April 6, 2012

Cogentrix Quail Brush Generation Project – Docket Number 11-AFC-3, Data Request Responses to Set 2

Transmission System Engineering

ATTACHMENT D
PREFERRED ROUTE

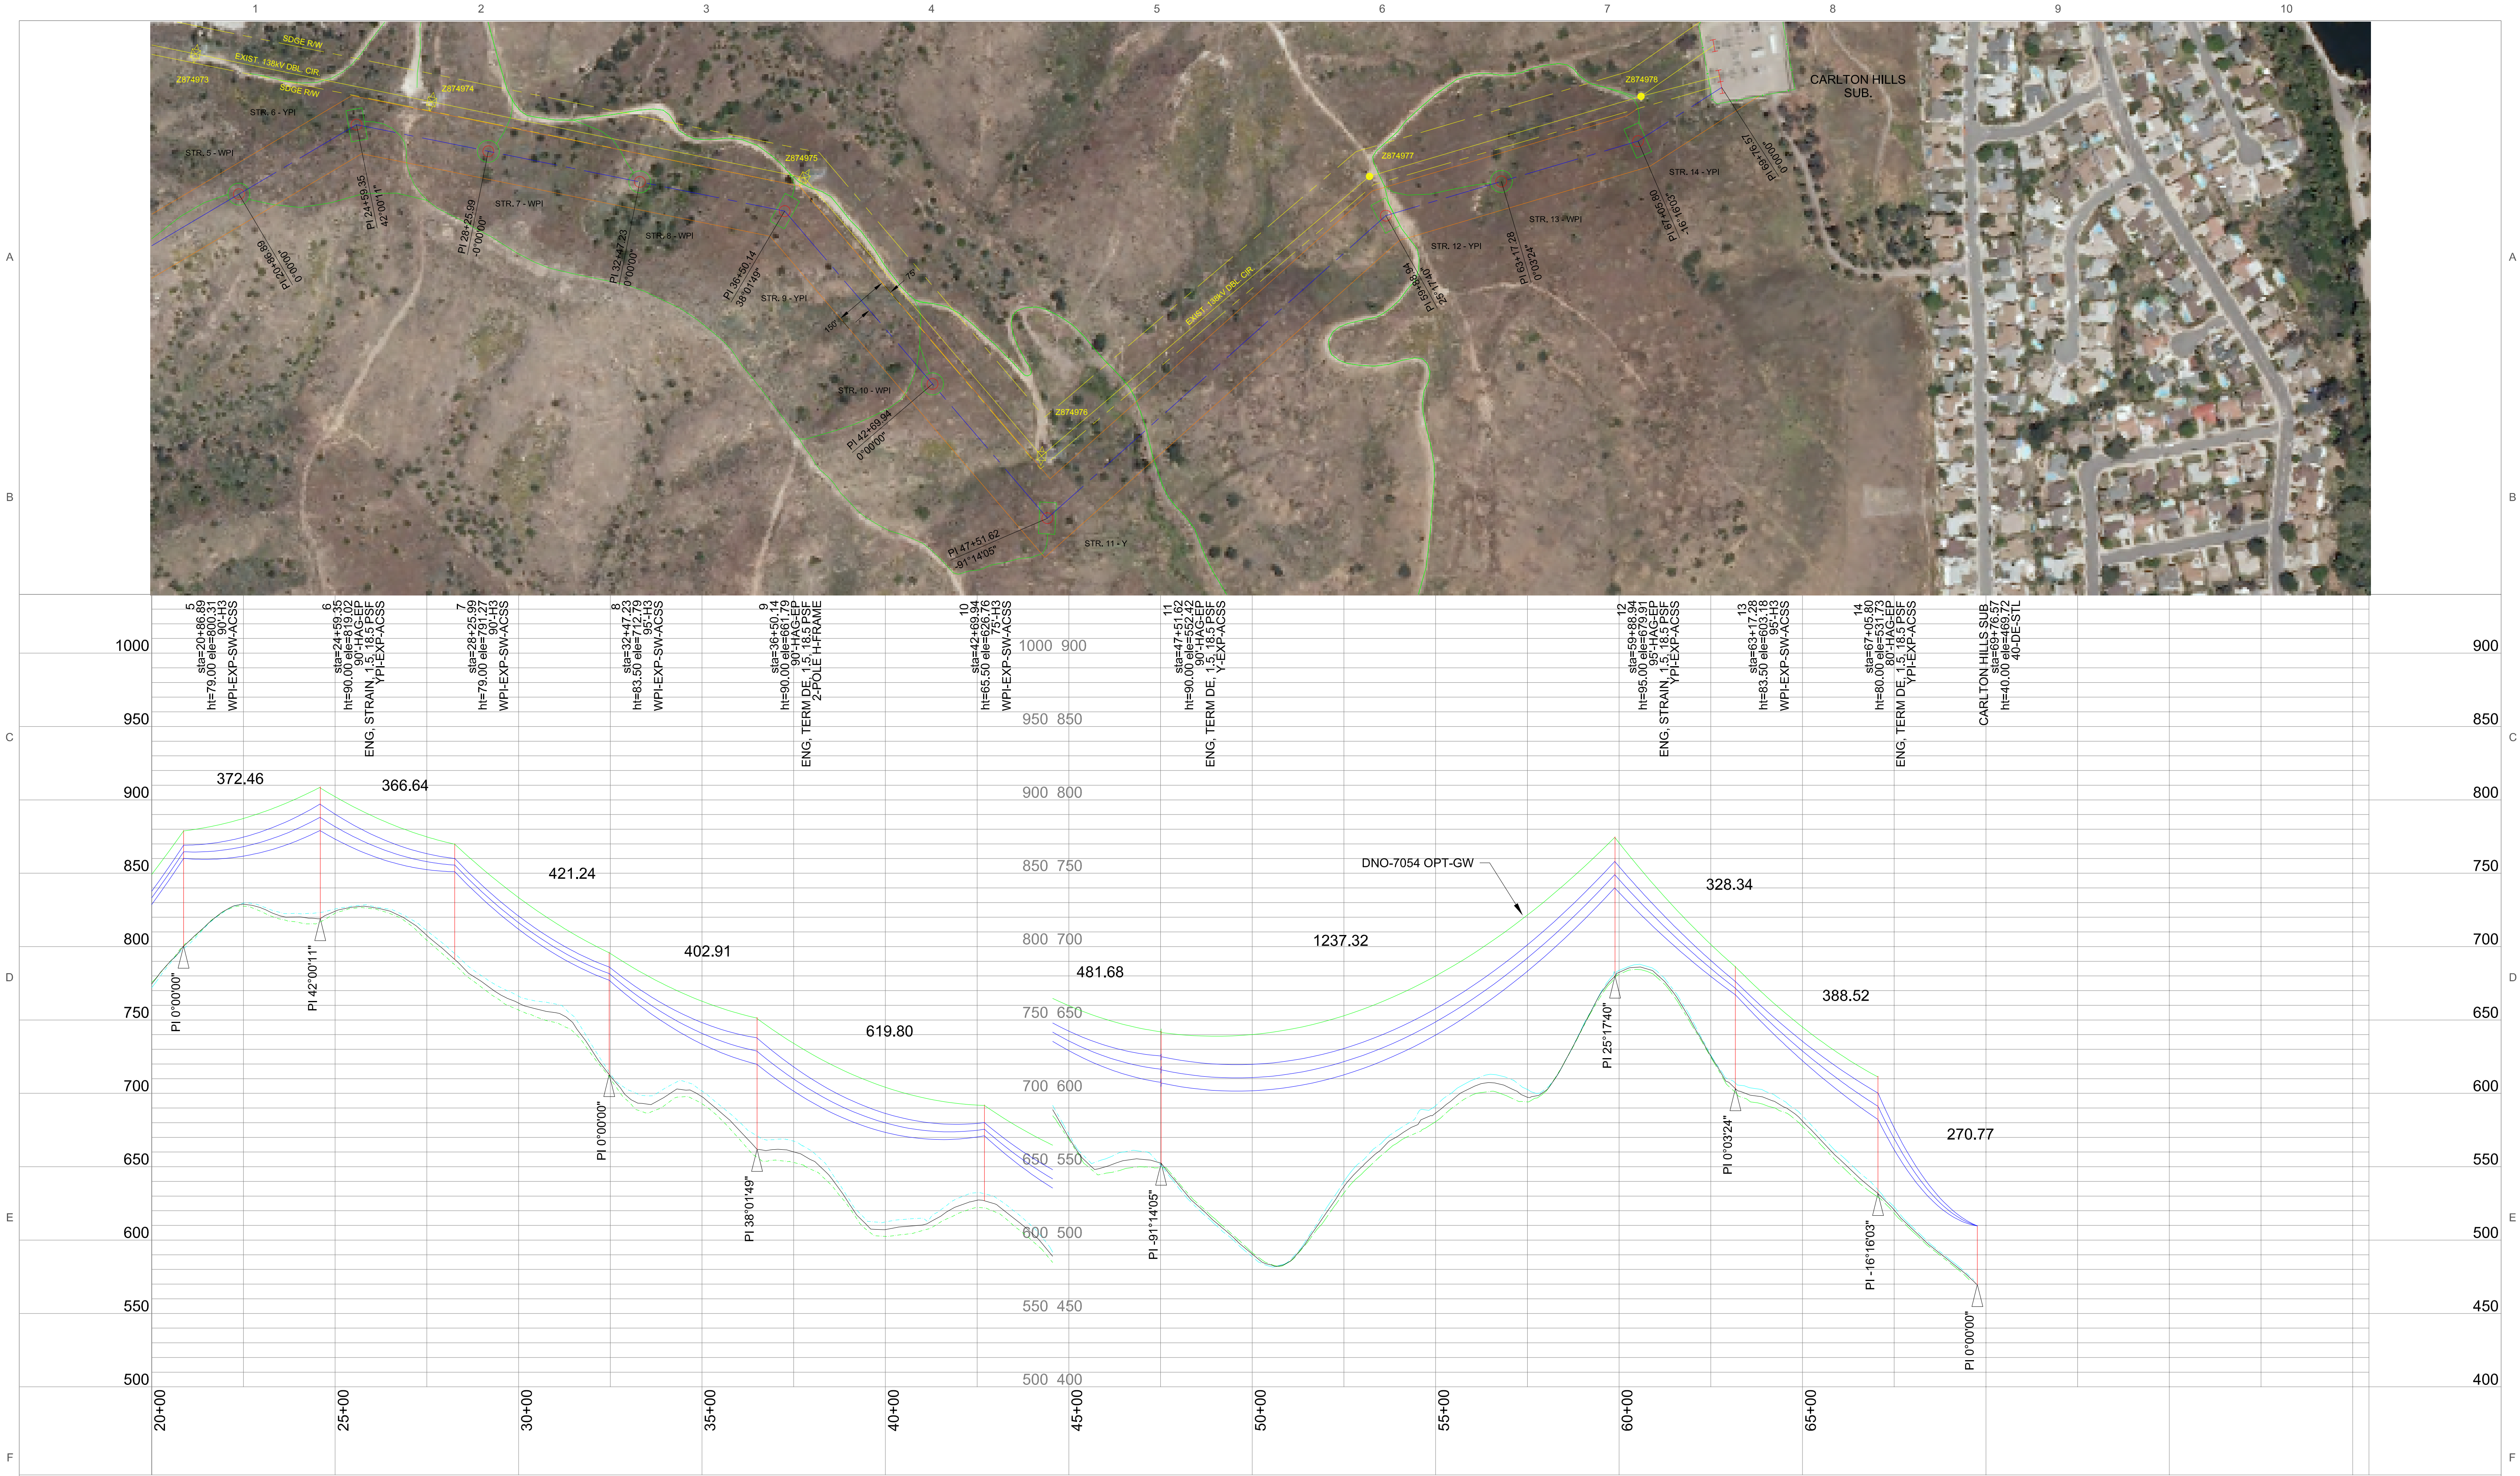
61. Please provide a discussion and drawing of the physical layout showing distinctly (in a larger scale) the preferred route (along any road or land or overhead line) of the proposed 6,850-foot long 138 kV overhead gen tie line including Right of Way (ROW) width(s) between the proposed QGBP 138 kV switchyard and the SDG&E 138 kV Carlton Hills substation. Describe whether the ROW would be through private and/or public lands.

The crossing of the existing SDG&E 138 kV line required in Alternative 2a and Alternative 2b will not be underground. The crossing would be accomplished by passing the gen tie underneath the SDG&E 138 kV transmission lines but above the ground. The required clearances from the gen tie conductors and SDG&E conductors, as well as, between the gen tie conductors and the ground shall be maintained. Plan and profile drawings for the Preferred, Alternate 2a, and Alternative 2b gen tie routes are included as Attachments D, E, and F, respectively.

In all cases the proposed Quail Brush gen tie right-of-way (ROW) width is 150 feet and runs entirely on private land.

ATTACHMENT G
PREFERRED ROUTE

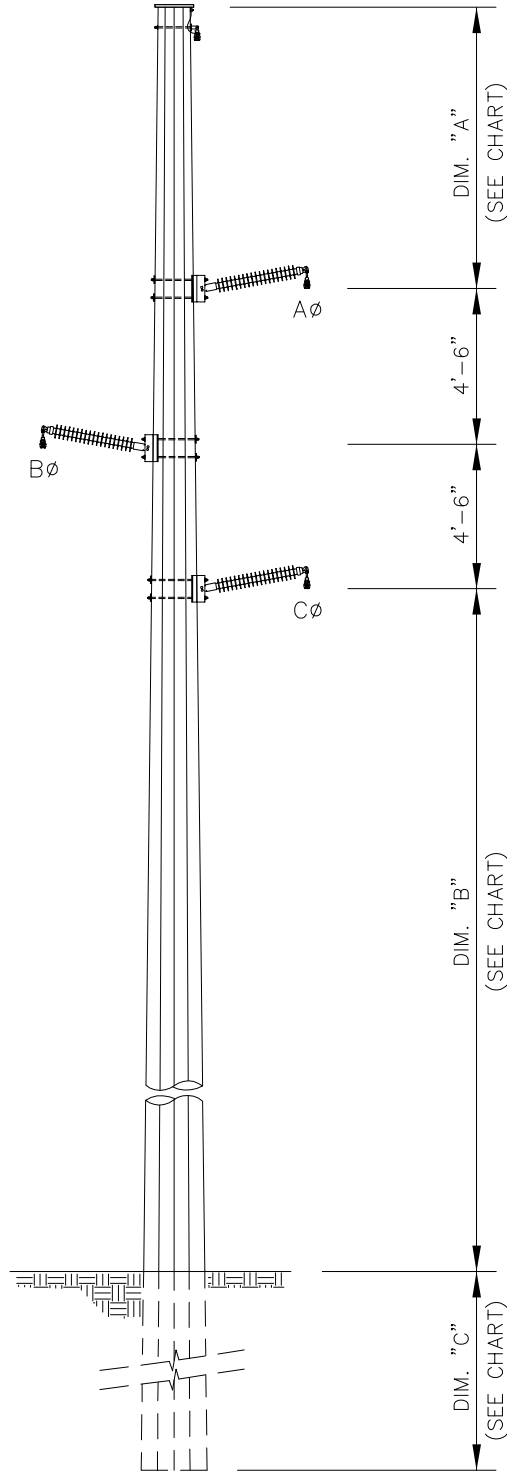
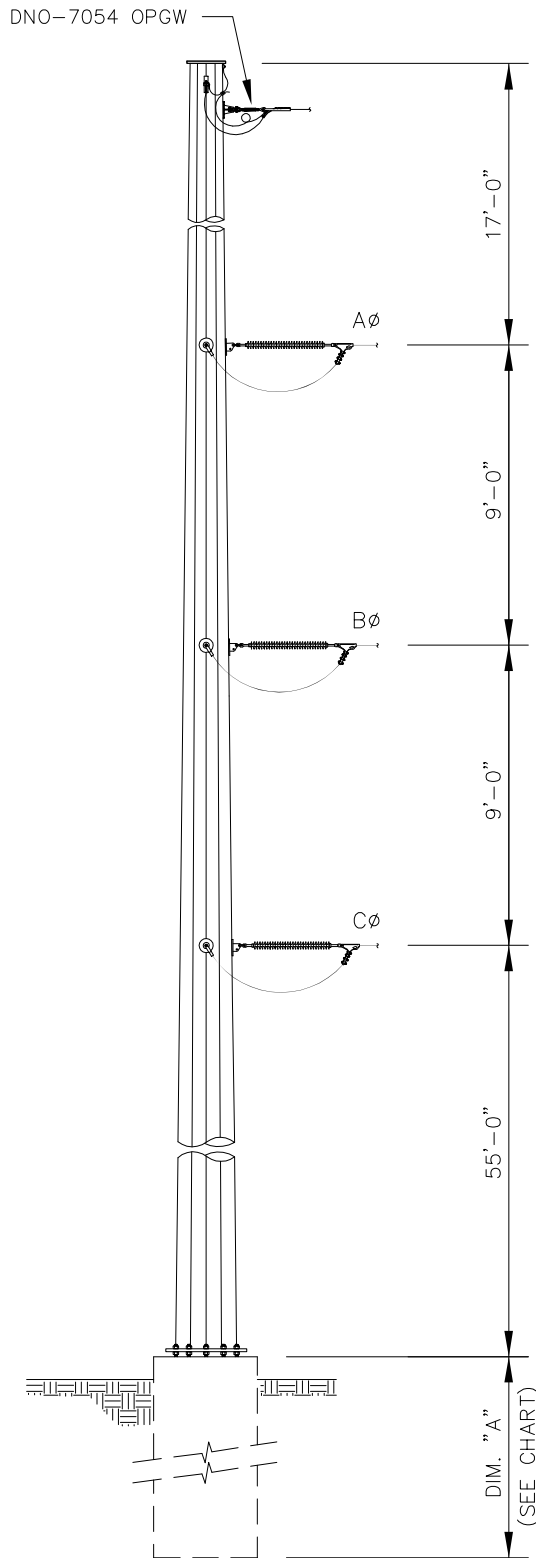
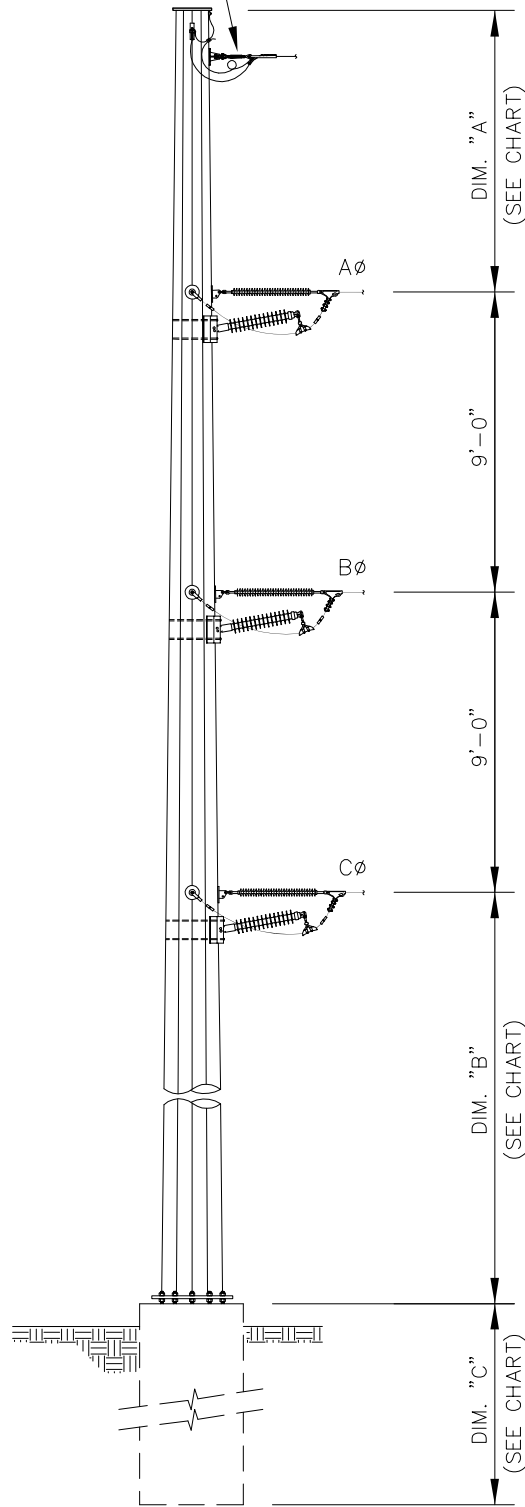
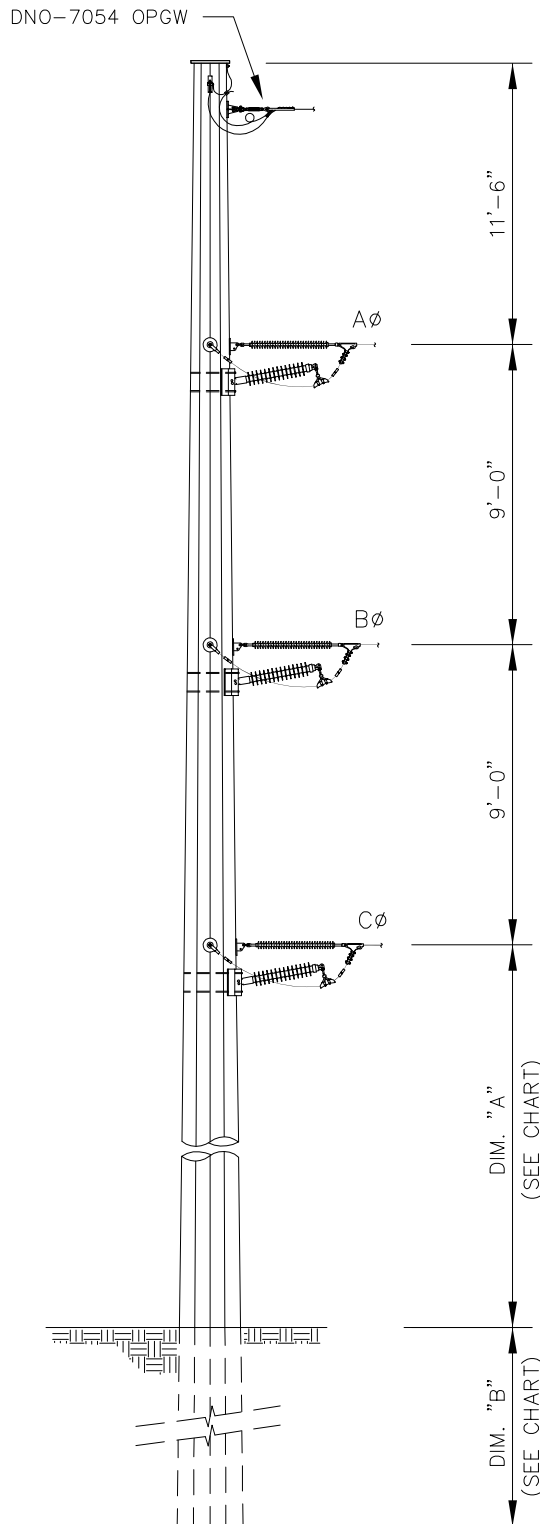
62. Please submit design diagrams of the tangent steel pole and heavy-angle steel pole showing configuration of insulators and conductors with their respective position measurements on the pole including ground clearance from the lowest conductor, height of the pole above and below ground, and the ground conductor, if any, with its size. Also include similar design diagrams of the dead-end poles or structures for the overhead gen tie line at each end.

The Preferred route has 14 structures and a detail sheet is provided for each (note the structure numbers are shown in the upper right hand corner of the detail sheets) in Attachment G. The Alternative 2a route has 16 structures and all detail sheets are provided in Attachment H. Structures 9 and 10 of the Alternative 2a route are not labeled as such but are detailed on the "H-Frame DE" sheet (Attachment I). The Alternative 2b route has 14 structures and all detail sheets are provided in Attachment J. Same as the Alternative 2a route, structures 9 and 10 are not labeled as such but are detailed on the "H-Frame DE" sheet (Attachment I). The preliminary design of these transmission poles and structures including foundations and burial depth will be finalized during the detailed design phase of the Project and once the final gen tie route has been selected.
